**GROWTH AND RESOURCE MANAGEMENT DEPARTMENT**  
**PLANNING AND DEVELOPMENT SERVICES DIVISION**  
**CURRENT PLANNING ACTIVITY**  
 123 W. Indiana Avenue, DeLand, FL 32720  
 (386) 736-5959

**CASE NO:** V-15-052

**SUBJECT:** Variance to the maximum off-street parking requirement on Heavy Commercial with Thoroughfare Overlay Zone (B-5C) and Heavy Commercial (B-5) zoned property.

**LOCATION:** South of the intersection of Woodland Boulevard and Beresford Avenue

**PRELIMINARY SITE PLAN - ACCESS 1  
#2944 - DELAND, FLORIDA**

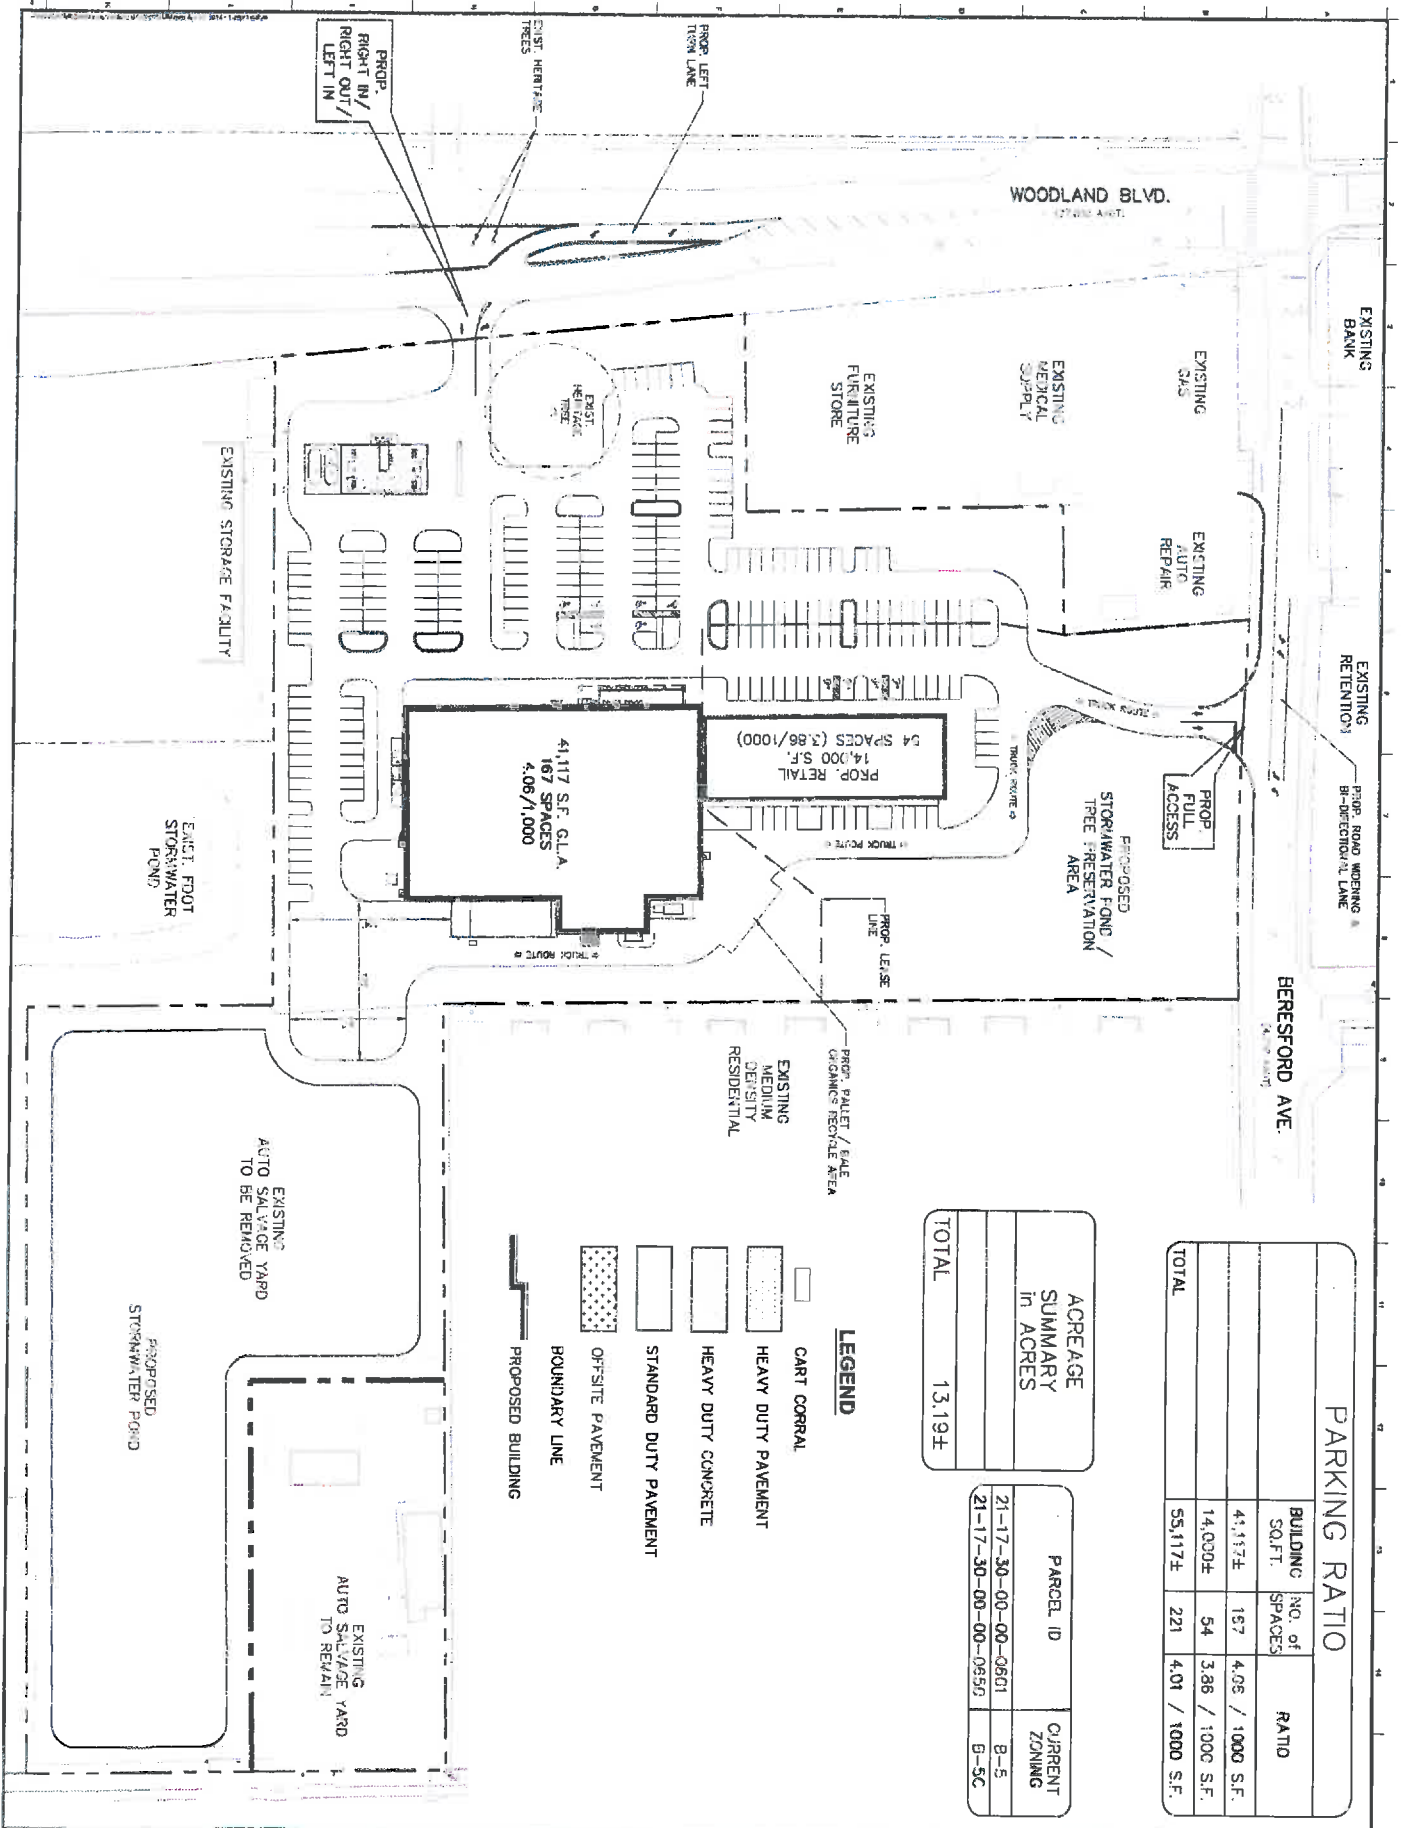
5. Revise the parking calculations on sheet C-5 to use the county's minimum and maximum parking calculations. If a variance is granted, the amount of parking granted shall also be referenced on the plans.

***The plan states 223 parking spaces are provide, not 220.***

11. Per Section 72-286(9) of the ZC, the grocery store requires three off-street loading spaces. Clearly identify the individual spaces on the plan. The retail building requires two off-street loading spaces. Revise sheet C-5 to show two loading spaces for the retail building.

- 22. On sheet C-5, label the underground gas tanks clearly.
- 23. Revise sheet C-11 by adding a note that all lights will be shielded and pointed down to reduce glare to adjacent property owners and the traveling public.
